PARKSIDE MONTESSORI MPR AND SITE PROJECT

ADDENDUM NO. 2

Date: November 6, 2023

Project: Parkside Montessori MPR & Site Project
DSA #: 01-120306 41-26

21. SHEET 'A10.32 CEILING DETAILS'

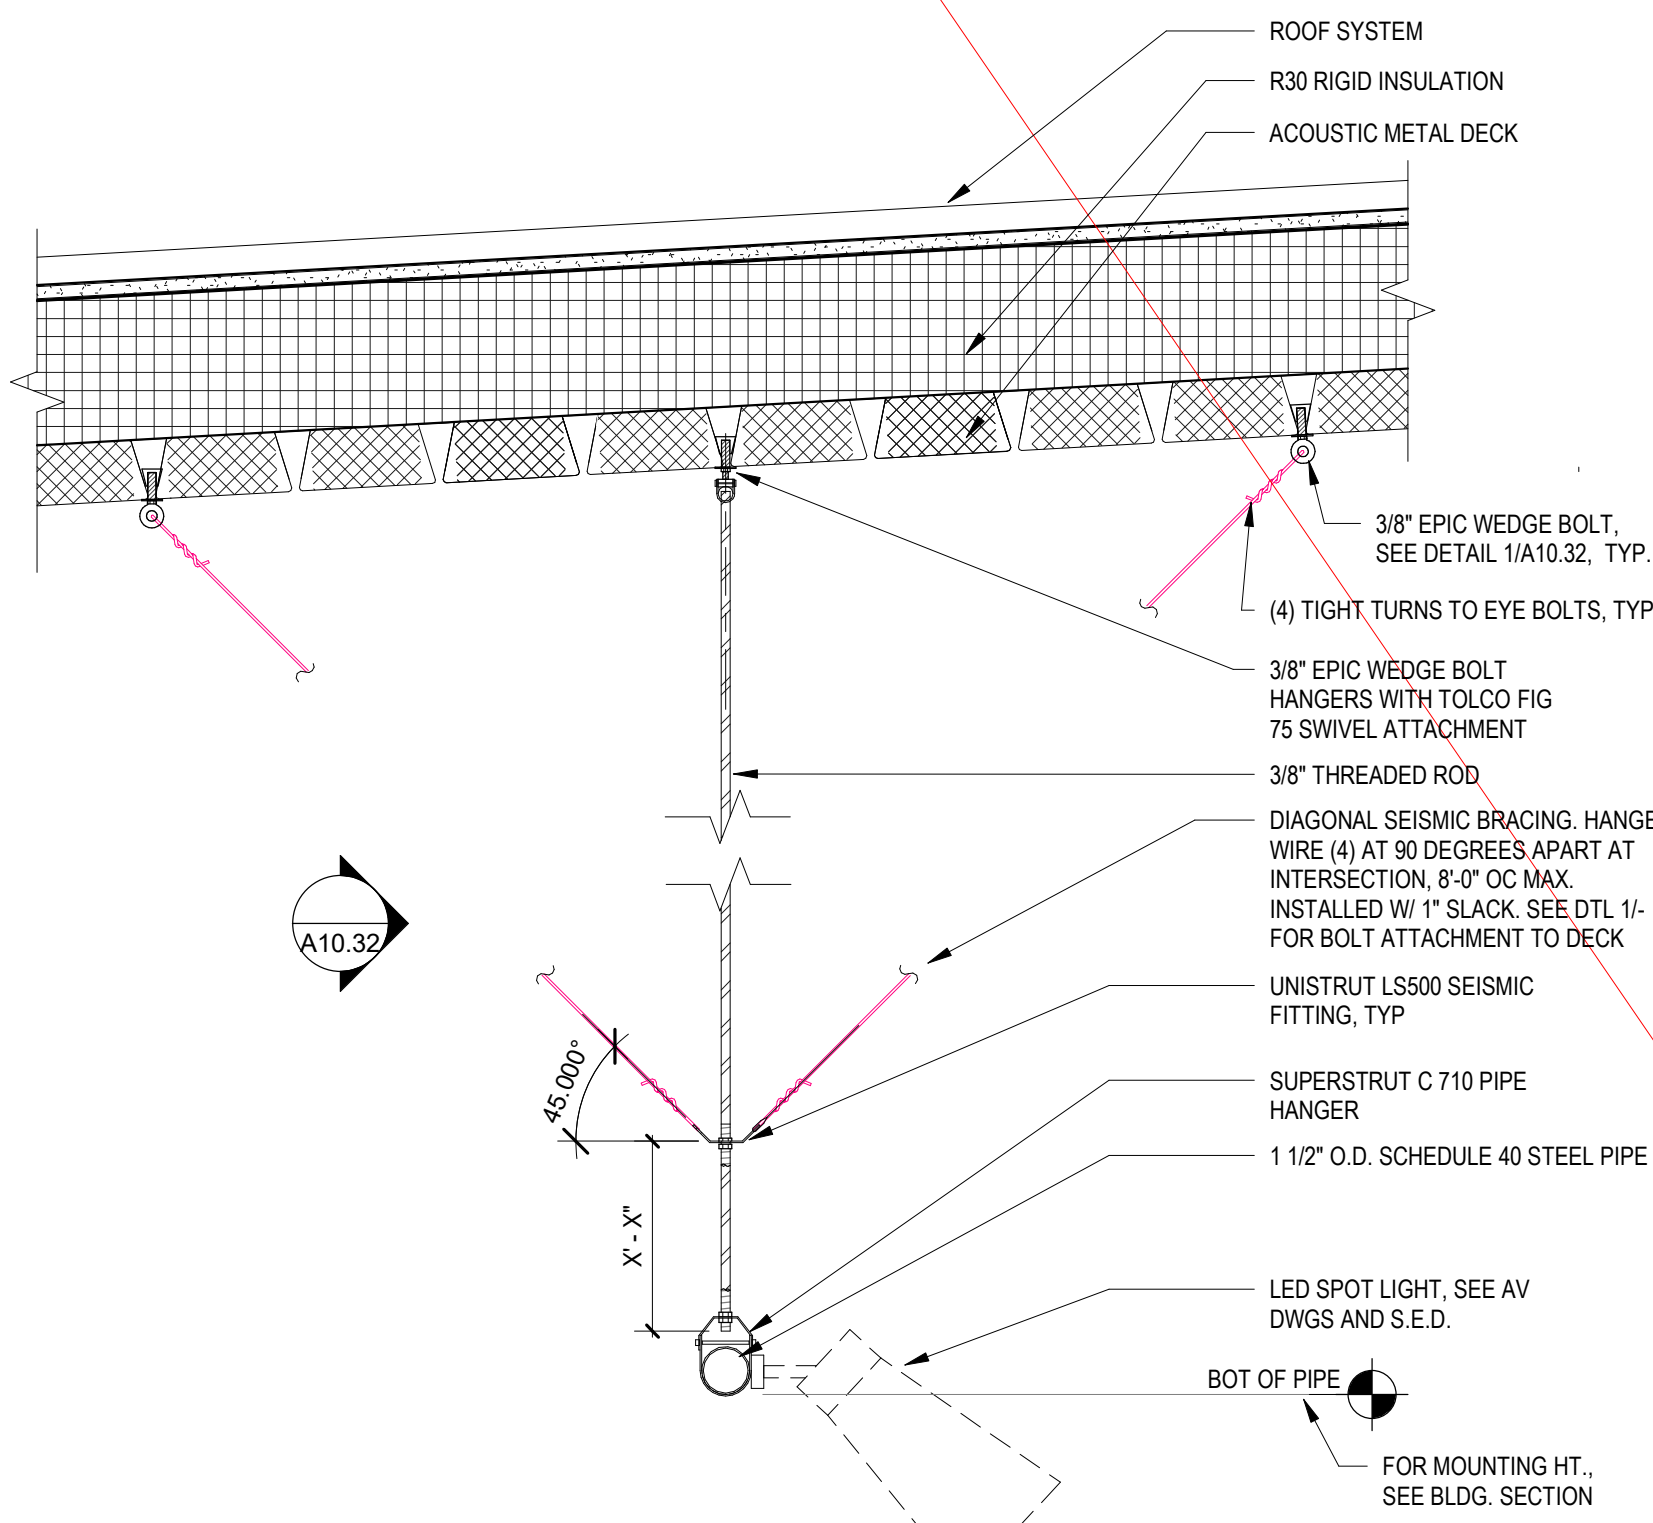
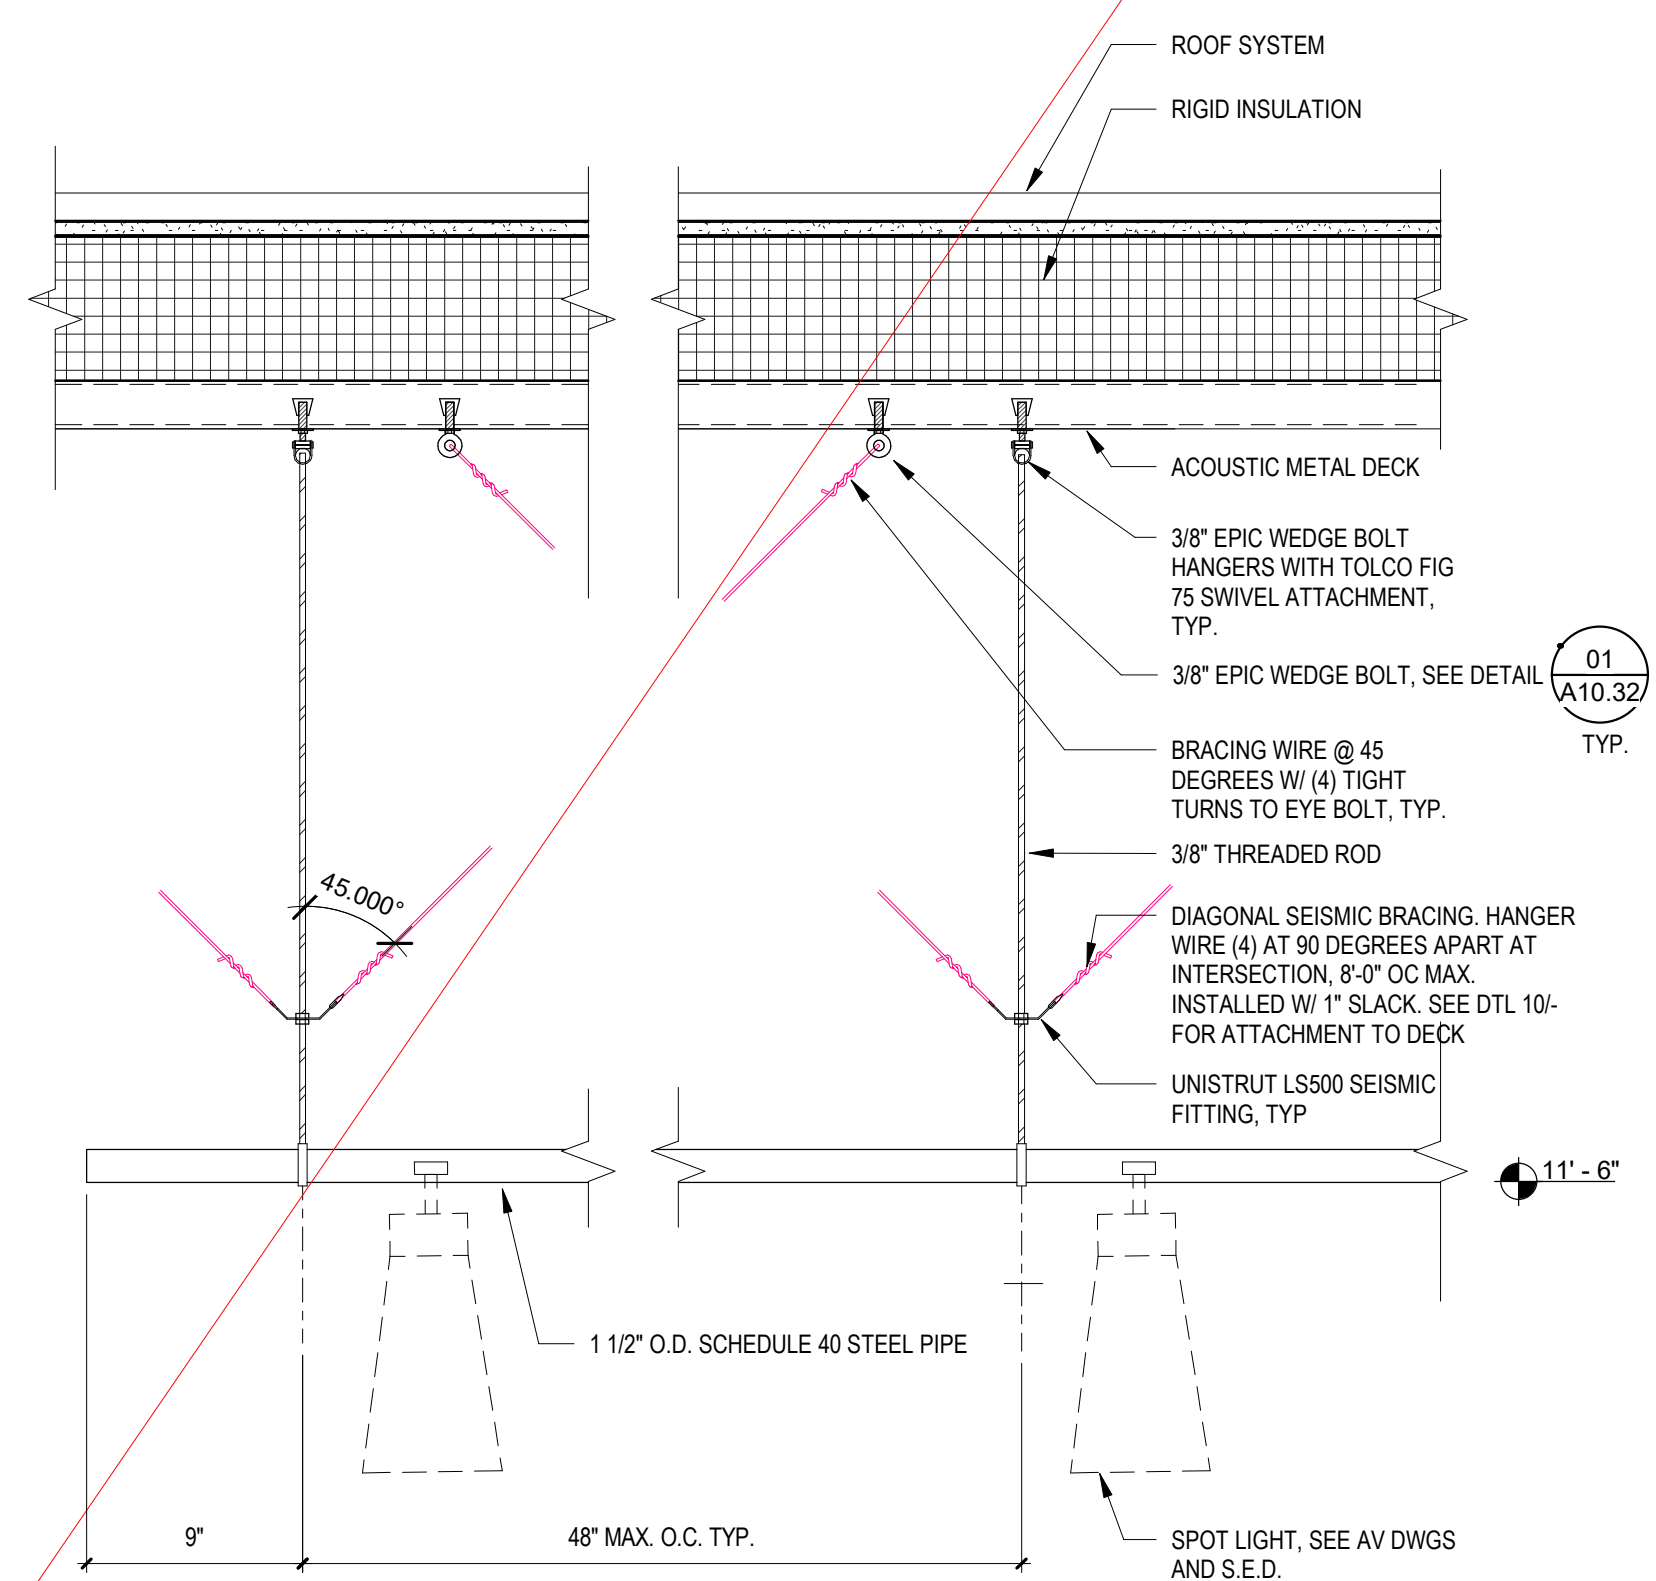
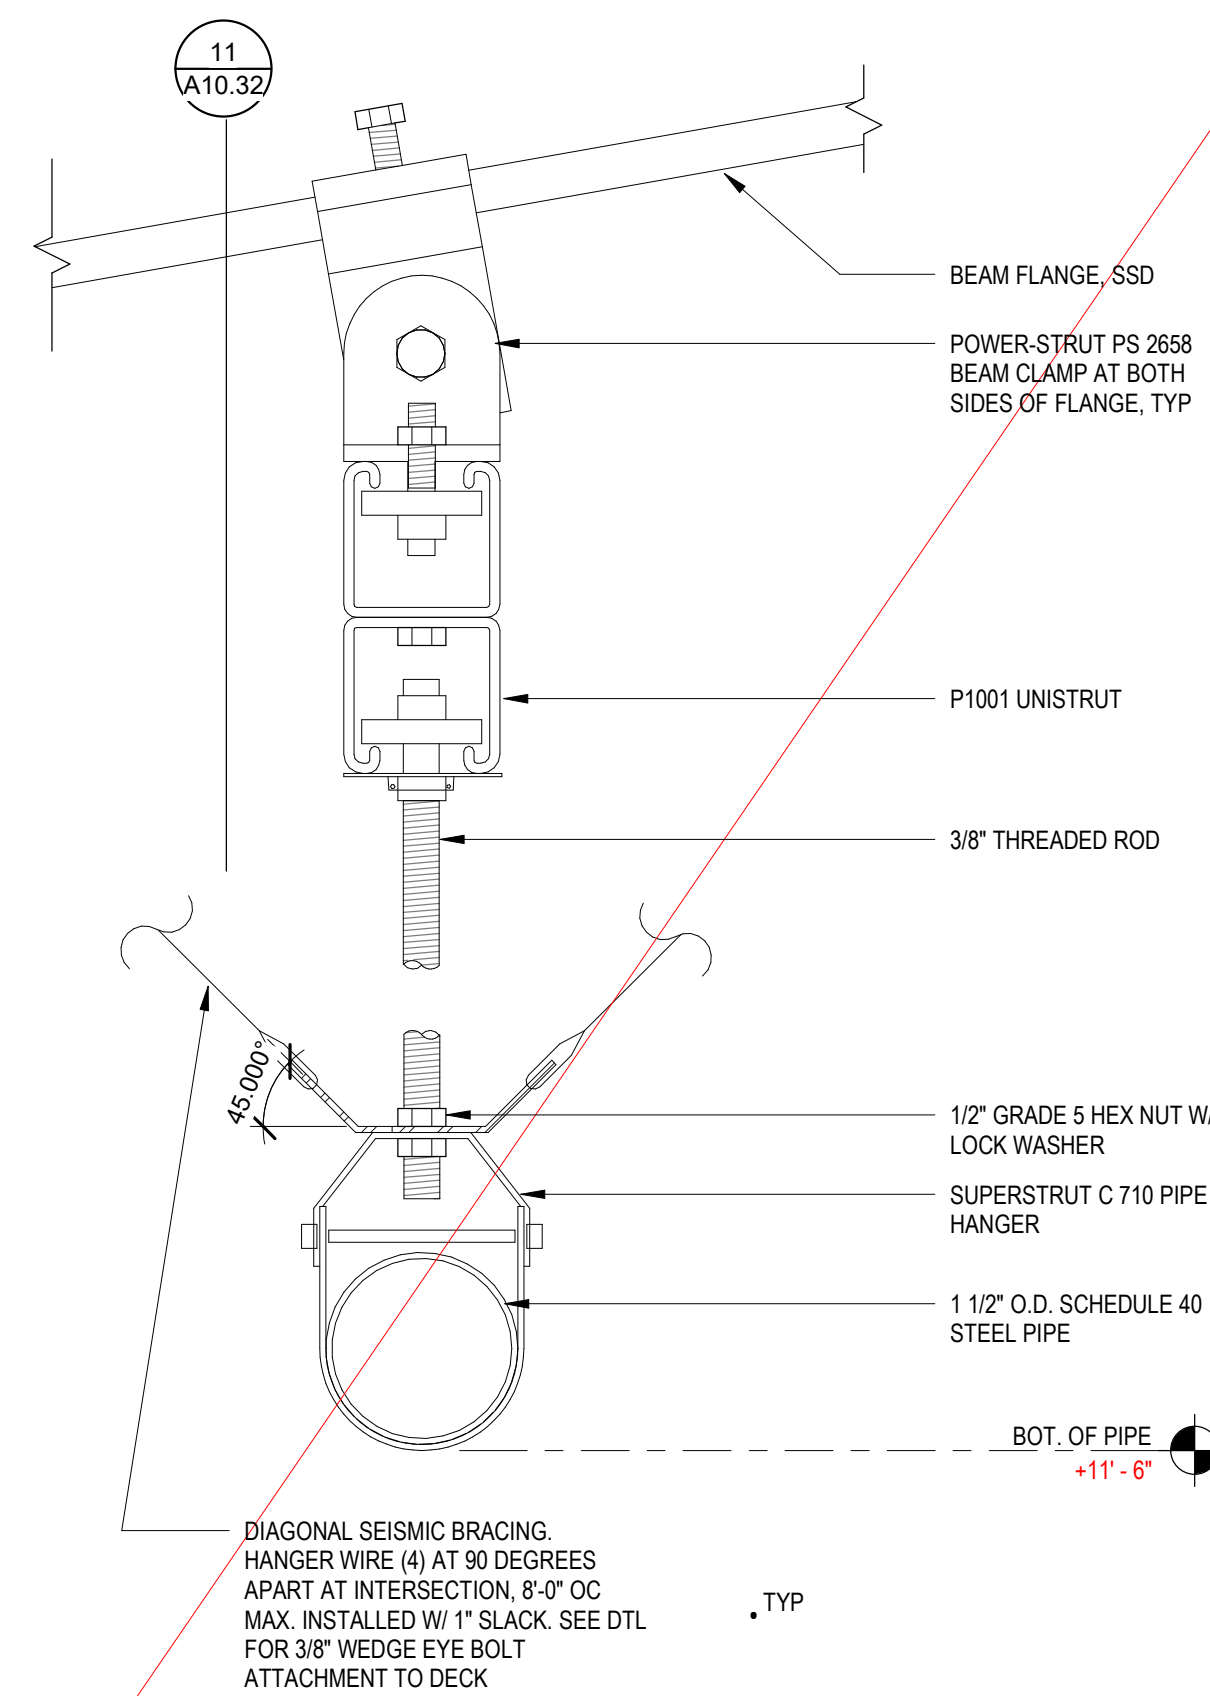
- A. Delete Details 11, 12, 14, 21 associated with theatrical lights support.
